Re: Docket No. 3B - The United Illuminating Company Amended Certificate of Environmental Compatibility and Public Need for Replacement of a Portion of the Existing Derby – Shelton 115-kV Electric Transmission Line Facility

TO: Mr. Kevin McMahon
 FROM: Benjamin Cotts, Ph.D.
 DATE: July 20, 2022
 PROJECT: UI Derby to Ansonia Transmission Line – 2005859.000
 SUBJECT: Magnetic Field Evaluation of Structure 4 Re-design

Figure 1. a) Originally proposed Structure 4 design with separate monopoles supporting the 1560-3 and 1594 Lines. b) Revised Structure 4 design with a single monopole supporting the 1560-3 and 1594 Lines

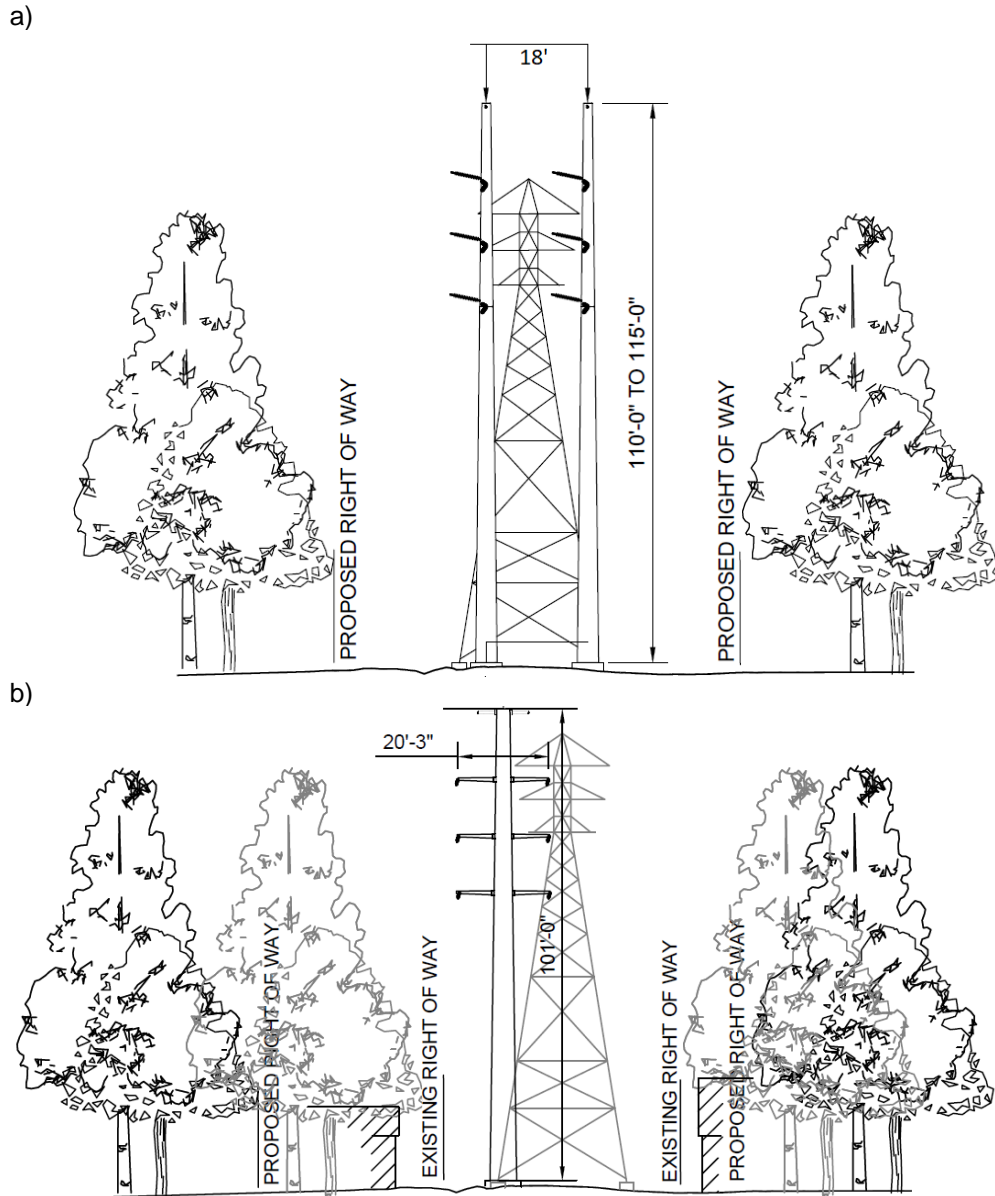
Figure 1 shows a comparison between the originally proposed Structure 4 design with the two proposed monopoles (a) and revised Structure 4 design (b) with both the 1560-3 and 1594 Lines supported on the same monopole structure. Figure 1 also shows that the revised monopole structure has slightly wider spacing (20’-3” compared to 18’) between conductors and is proposed to be offset by approximately 10 feet to the west from the centerline of the original

structure.² This change will slightly increase magnetic-field levels at ground level and also shift the location of the maximum magnetic-field level slightly to the west compared to the original Structure 4 design. Magnetic-field calculations made for the 3-dimensional models of the transmission line structures are shown in Figure 2.

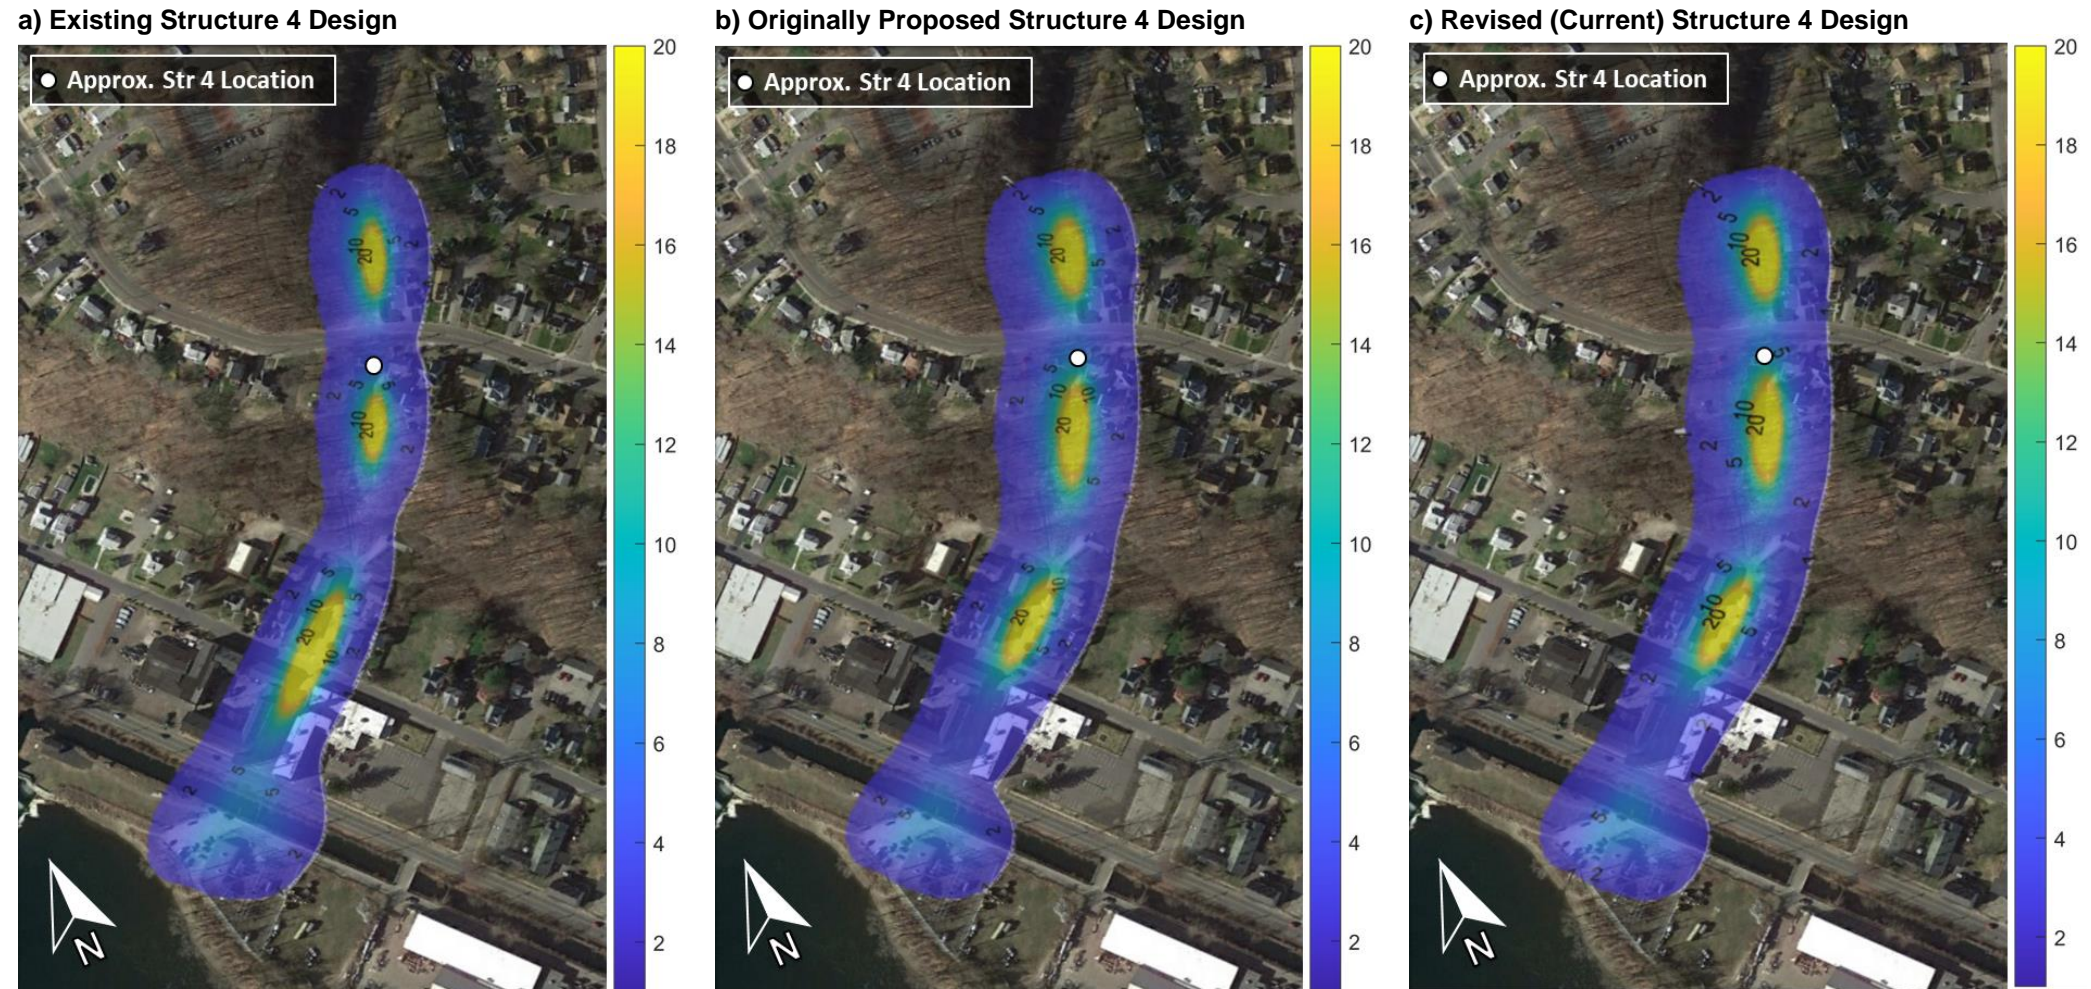
Calculated magnetic-field levels at a height of 3.3 feet (1 meter) above ground are shown for three configurations; the existing configuration in Figure 2a), the originally-proposed Structure 4 design in Figure 2b) and the revised (current) Structure 4 design are shown in Figure 2c).

Consistent with Exhibit E, these calculations show that the magnetic-field levels near ground decrease dramatically near where conductors are higher above ground as they approach suspension points on supporting structures compared to the midspan (where conductors are closer to ground). These results also show that the differences between the magnetic-field levels for the originally proposed Structure 4 design and the revised (current) Structure 4 design are quite small. The highest field for either configuration is near the midspan and is approximately 32 mG for either proposed structure design. Additional analysis shows that, as expected, the maximum magnetic-field level shifts slightly to the west for the revised Structure 4 design compared to the original Structure 4 design. However, at approximately 50 feet from the original structure centerline the difference between the magnetic-field level for the original and revised Structure 4 designs is less than 1.5 mG. These results also show that the distance at which magnetic-field levels from the transmission lines fall to 1 mG or less is quite similar for the existing and the originally proposed or revised Structure 4 configurations.

All calculated magnetic-field levels were a very small fraction (approximately 2% or less) of the limits set by two international scientific organizations—the International Committee on Electromagnetic Safety (ICES) and the International Commission on Non-Ionizing Radiation Protection (ICNIRP)—which have developed magnetic-field limits designed to protect public health and safety. These organizations based their standards on weight-of-evidence reviews and evaluations of relevant health research. The limits set forth by these organizations are 2,000 mG (ICNIRP) and 9,040 mG (ICES).³
